N341NAS1

# TECHNICAL BULLETIN

Non-Compliance Recall: Front/Rear Windshield Washer Pump Fuses

MODEL:	MODEL YEAR:	VIN:	ASSEMBLY PLANT:
New Range Rover Evoque (LZ)	2020	000001-019200	Halewood

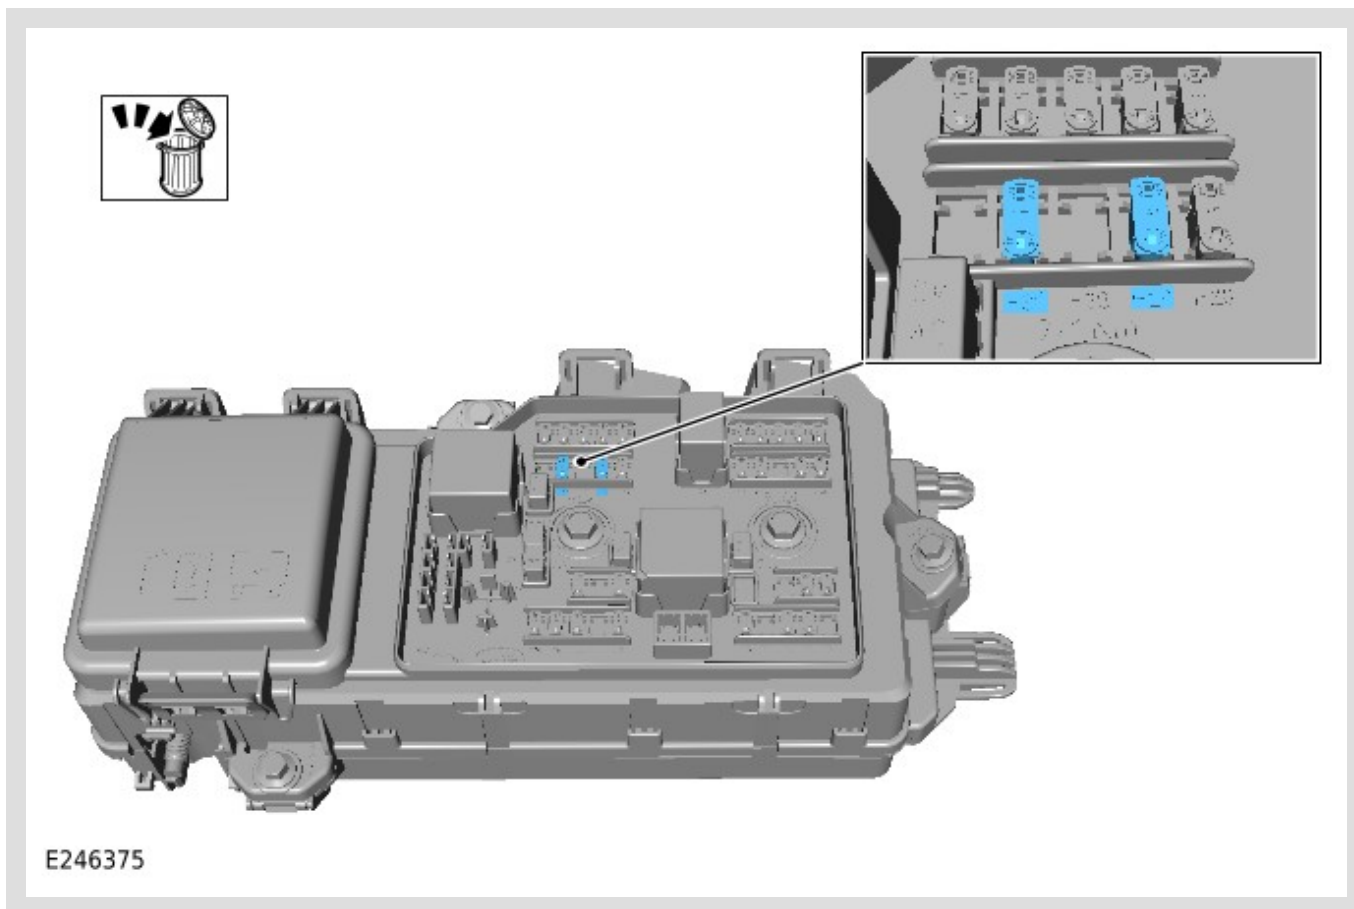
Remove and discard the Engine Junction Box (EJB) right cover.

- 1 Release 2 retaining clip(s).
- 2 Raise the EJB cover as shown.

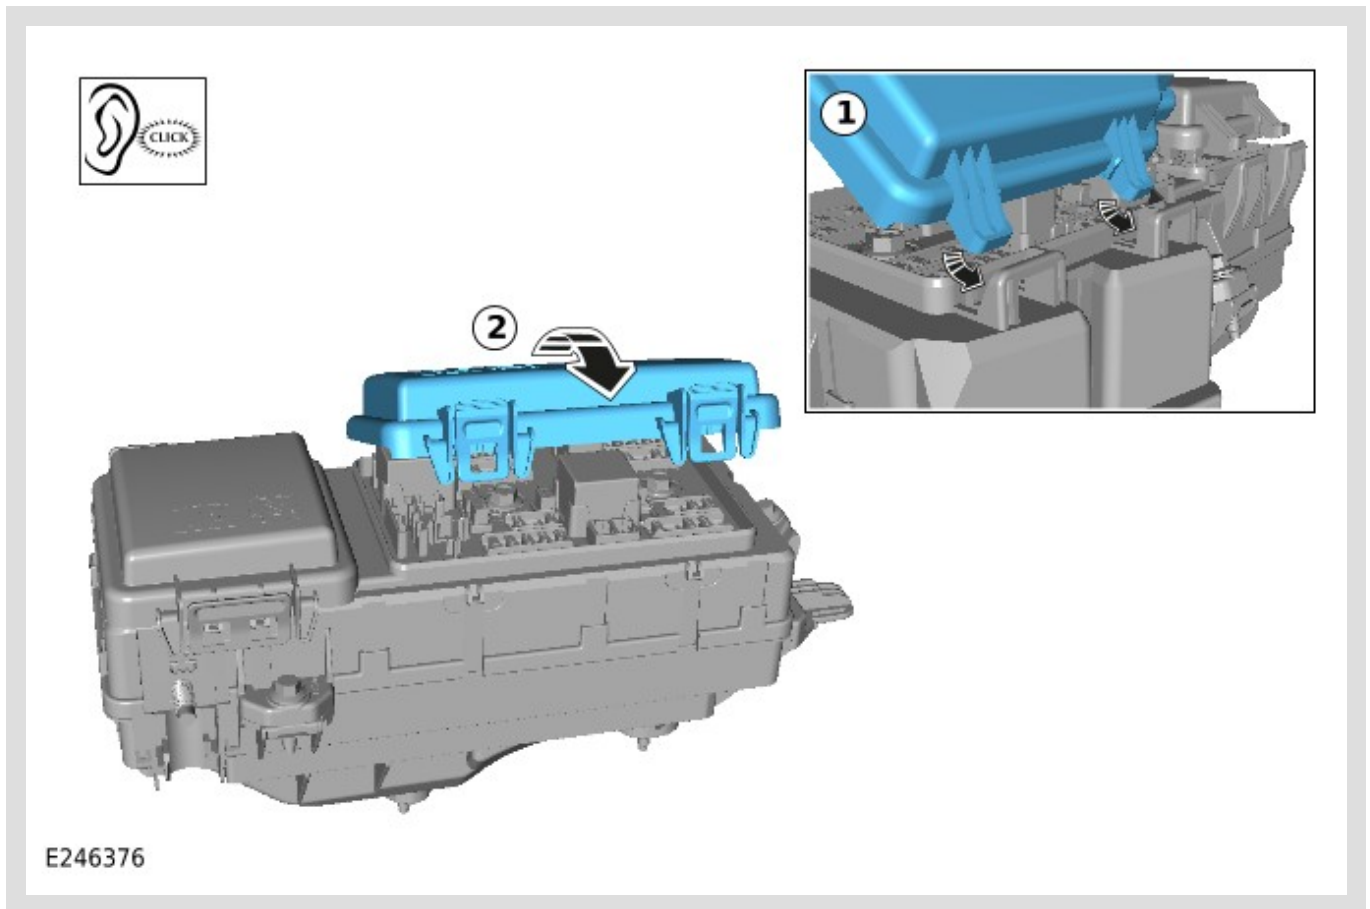
Remove and discard the 15A fuses installed in 'F29' and 'F31' locations.

5 Install new 25A fuses in 'F29' and 'F31' locations.

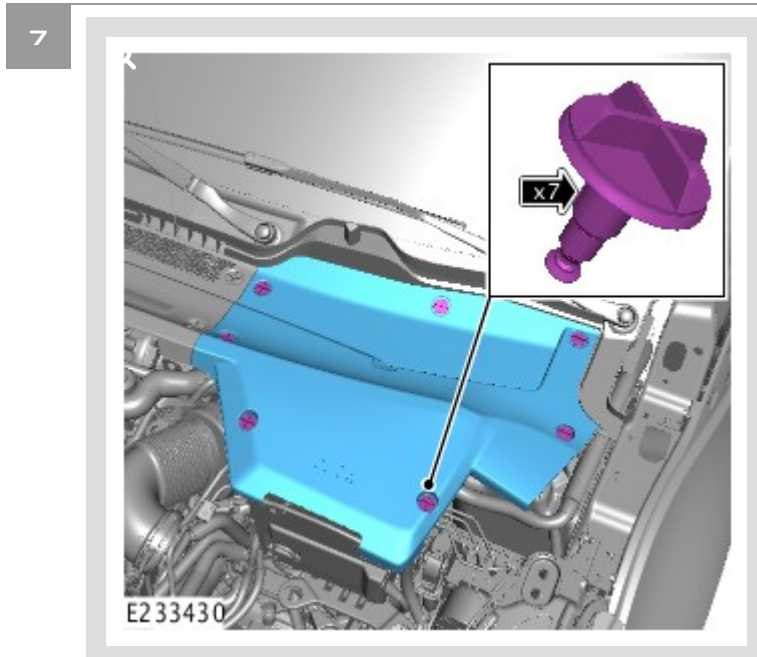
Make sure the rear of the EJB cover is located correctly.

Install the new EJB right cover.

- 1 Position the EJB cover as shown.
- 2 An audible 'click' will be heard when the EJB cover is secured.
